**BRADBURY PLACE TOWNHOMES**  
A PORTION OF SECTION 3, TOWNSHIP 19N, RANGE 04 E, W.M.  
CITY OF PUYALLUP, PIERCE COUNTY, WASHINGTON

SHEET TITLE: COVER SHEET AND HORIZONTAL CONTROL

PROJECT:	20-223
DWG NAME:	20-223 C
SHEET	REV.
C1	0
1 OF 28

SHEET TITLE: 27TH AVE SE PLAN AND PROFILE CLIENT: BRADBURY PLACE LLC 7809 PACIFIC AVE TACOMA, WA 98408 CONTACT: KEN RODY PHONE: (253) 318-5711	DESIGNER: M. GOULARTE ENGINEER: J. HAUG DRAWN: R. HENRETTA S 03 T 19 N R 04 E WM DATE: 3.17.2026 REVISED: PROJECT: 20-223 DWG NAME: 20-223 C
---	---

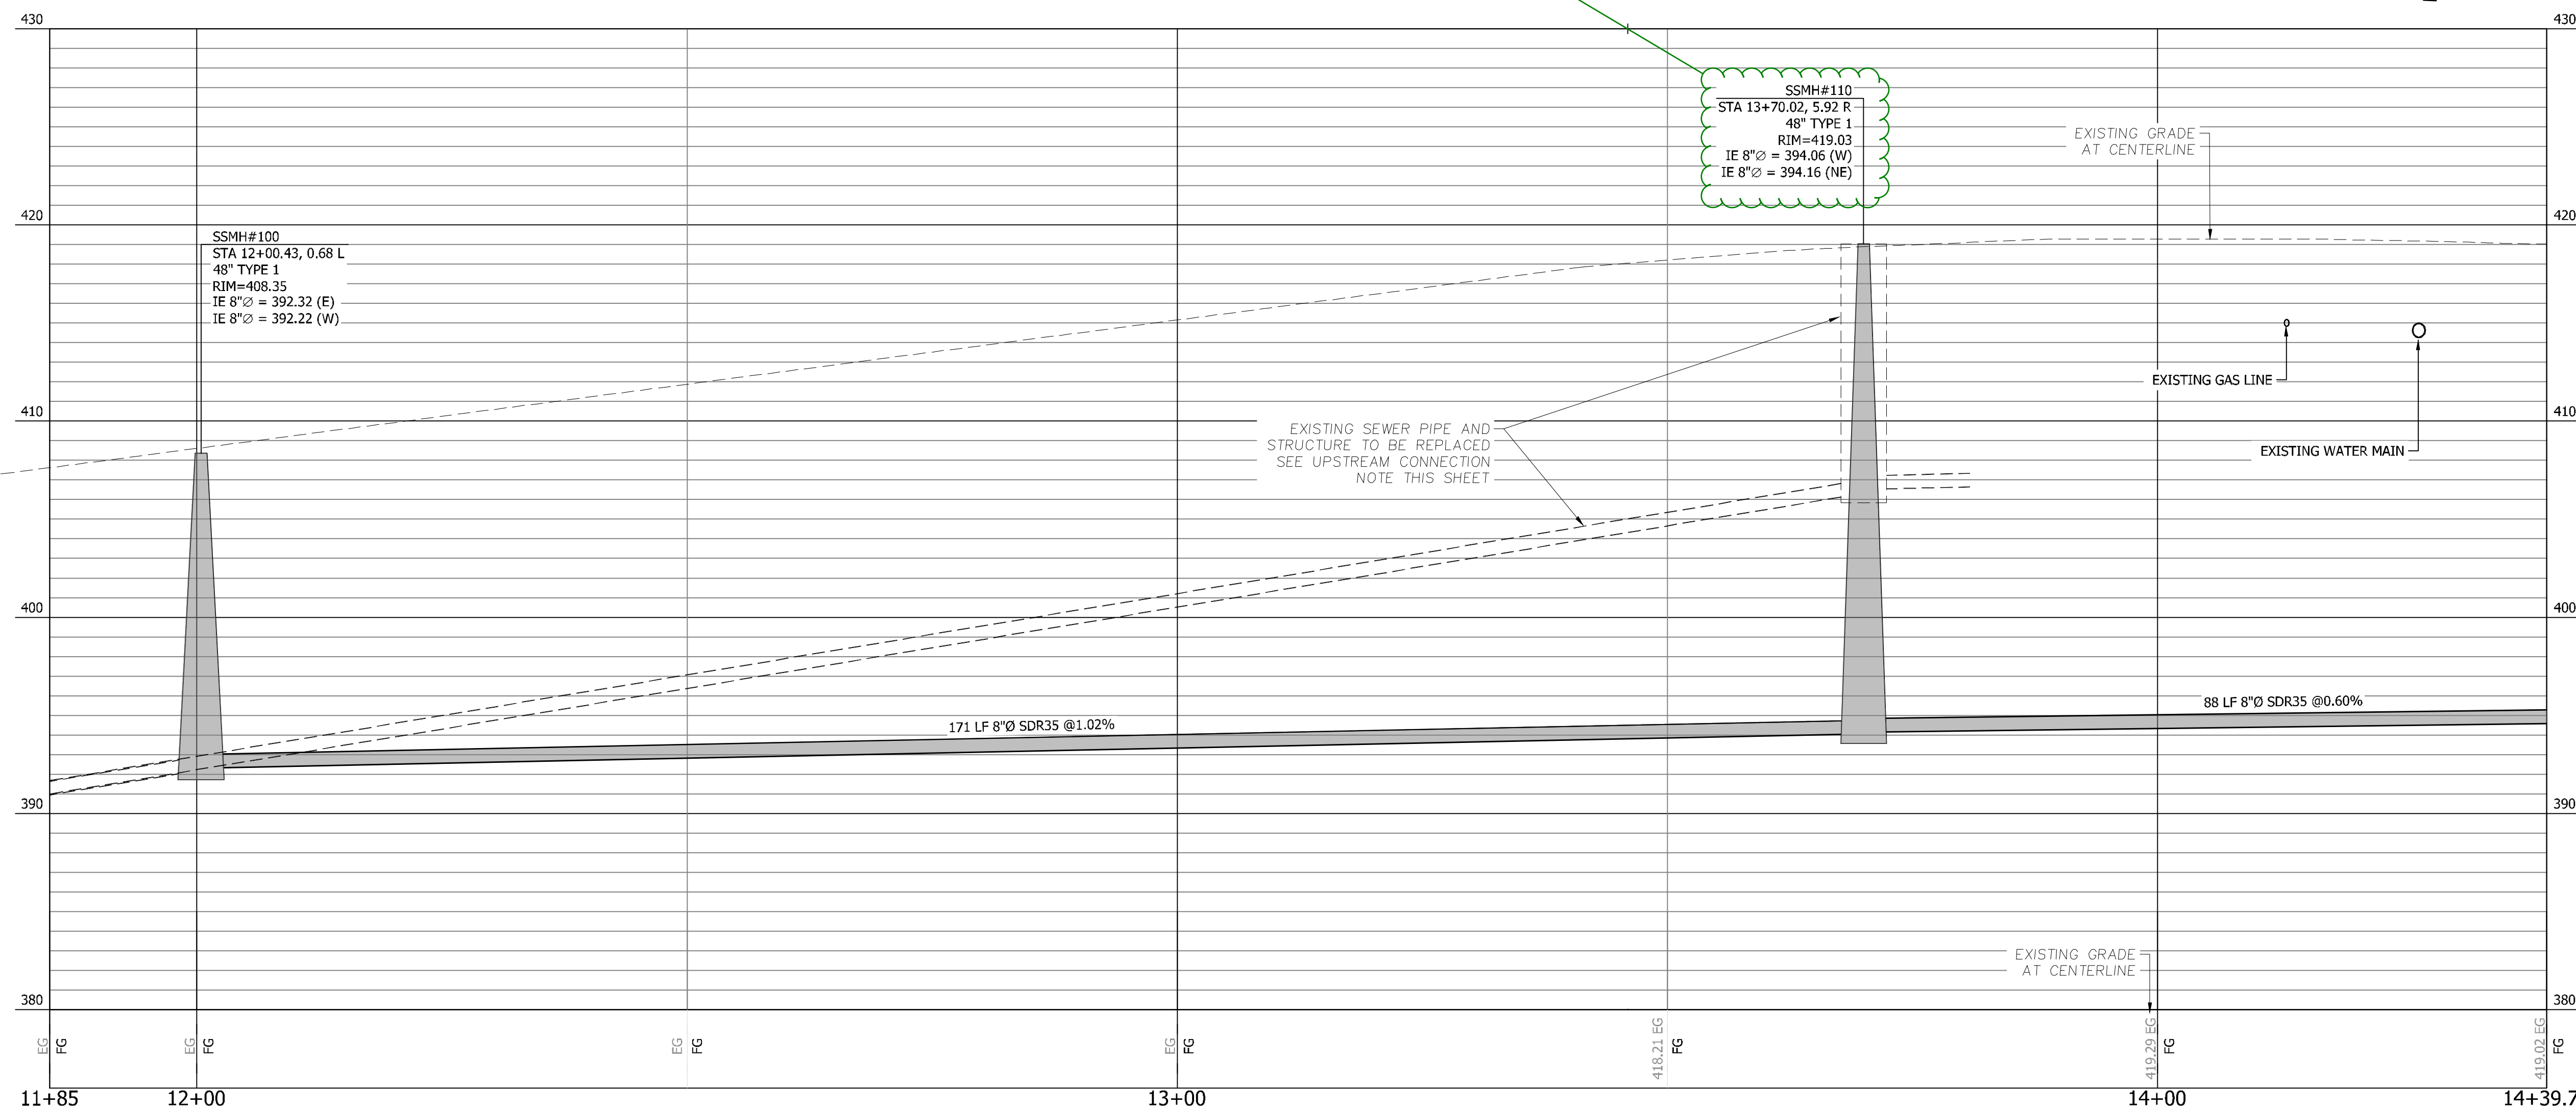
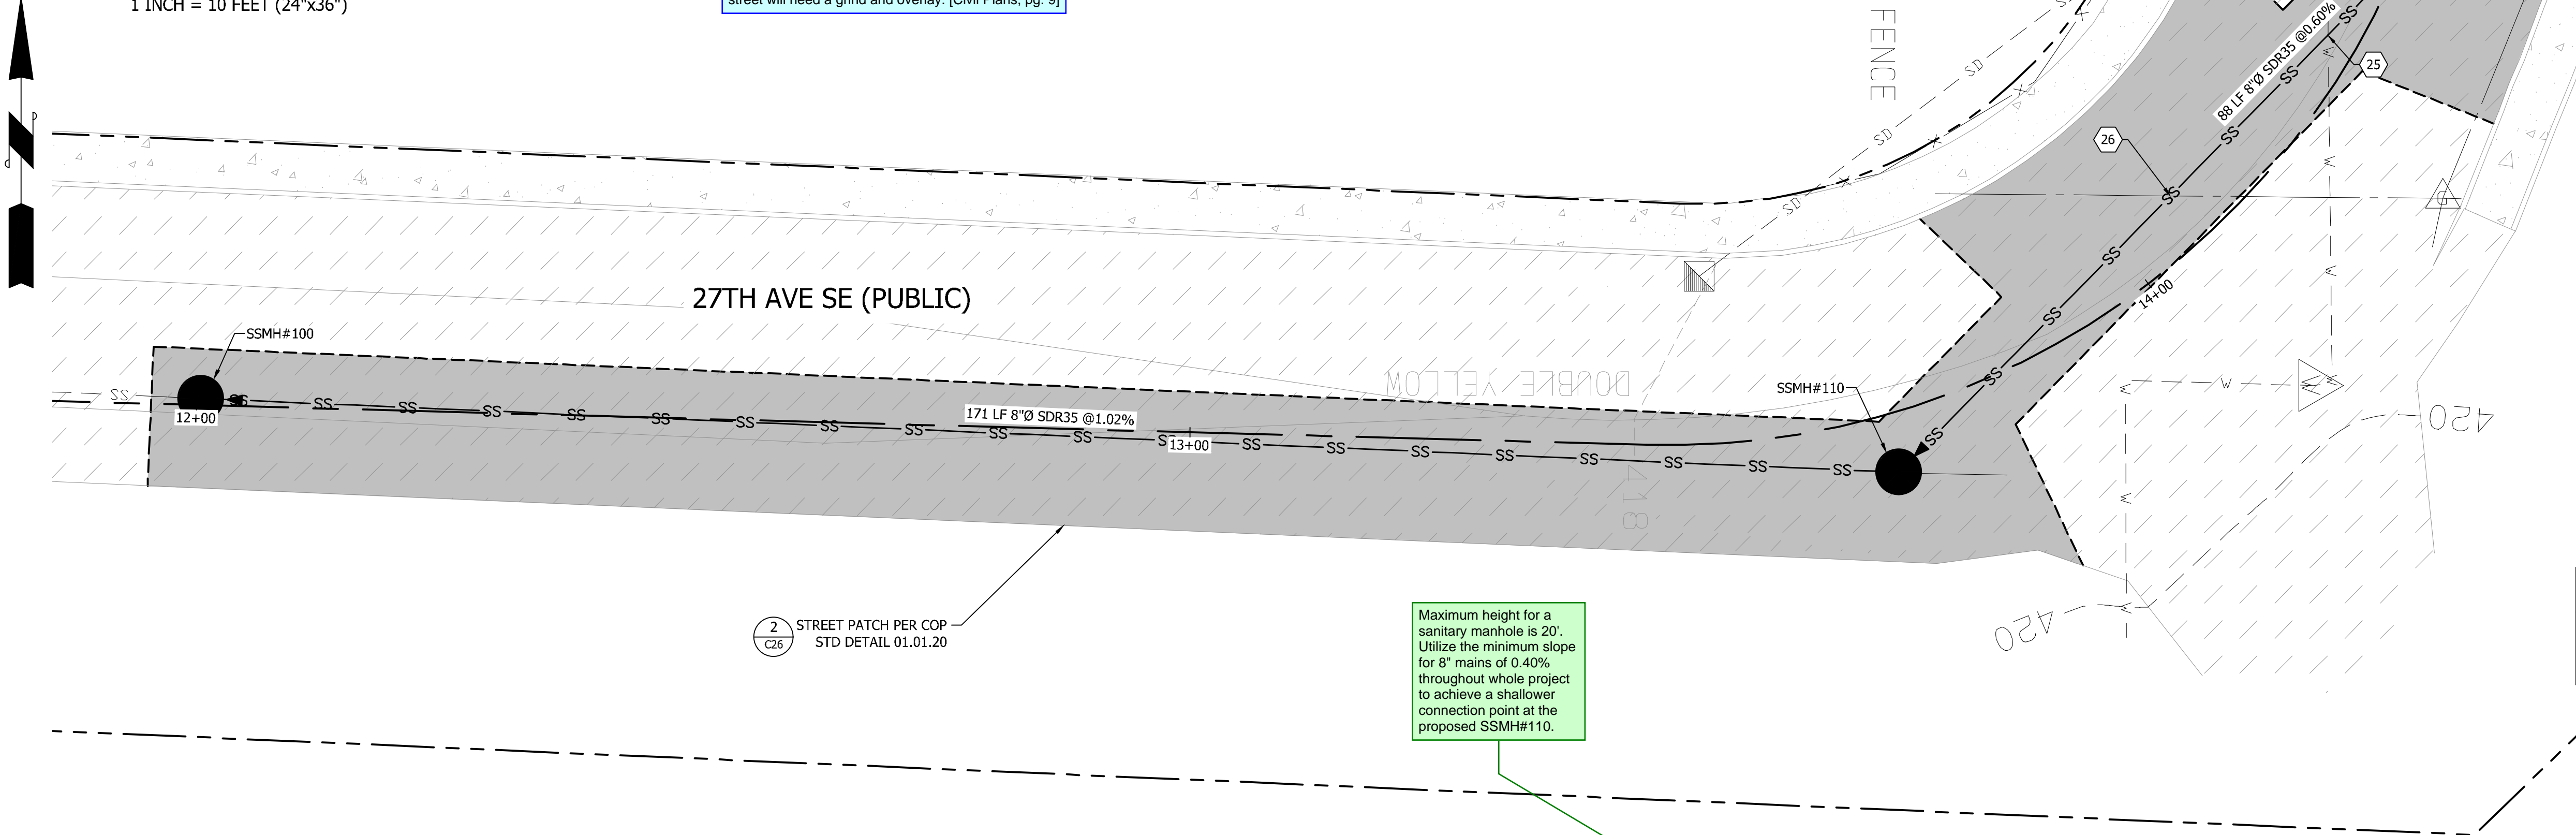
Several of the Roadway Notes from Section 104 of the City's standards were left off of this list. Update to include all notes. [Civil Plans, pg. 9]

The pavement restoration limits shown is closer to being shown correctly. Where the disturbance will impact a lane/half street, the full width of that half street will need a grind and overlay. [Civil Plans, pg. 9]

SHEET TITLE: 5TH ST SE PLAN AND PROFILE  
CLIENT: BRADBURY PLACE LLC  
7809 PACIFIC AVE  
TACOMA, WA 98408  
CONTACT: KEN RODY  
PHONE: (253) 318-5711

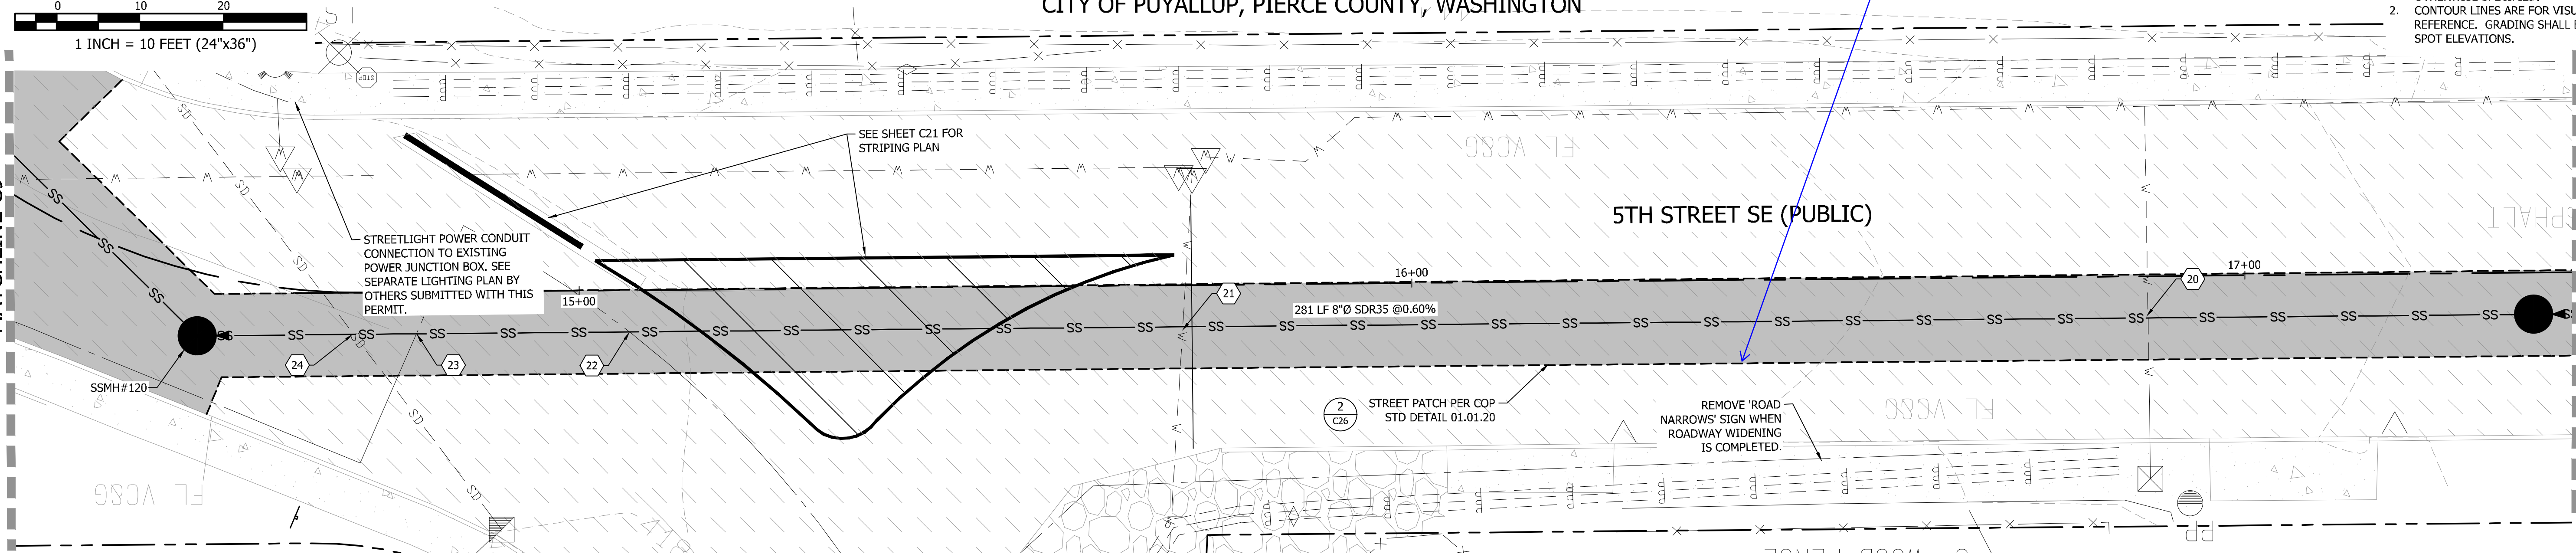
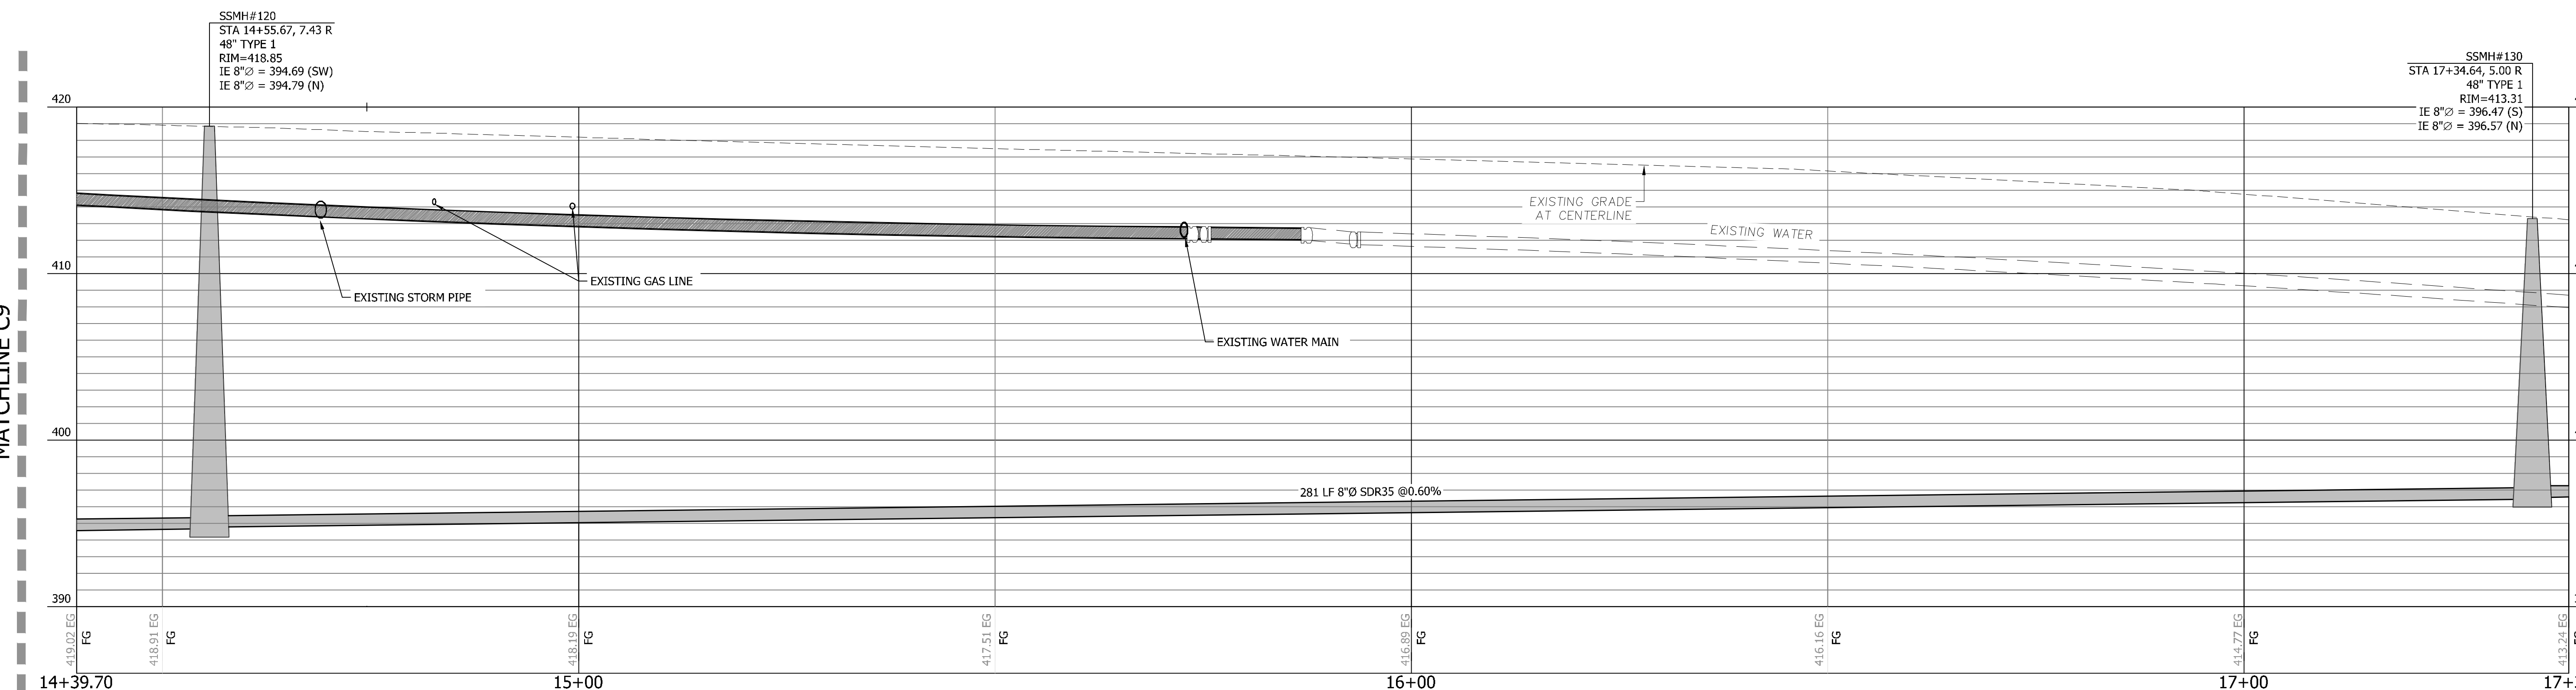
This will need to be a full half street grind and overlay. [Civil Plans, pg. 10]
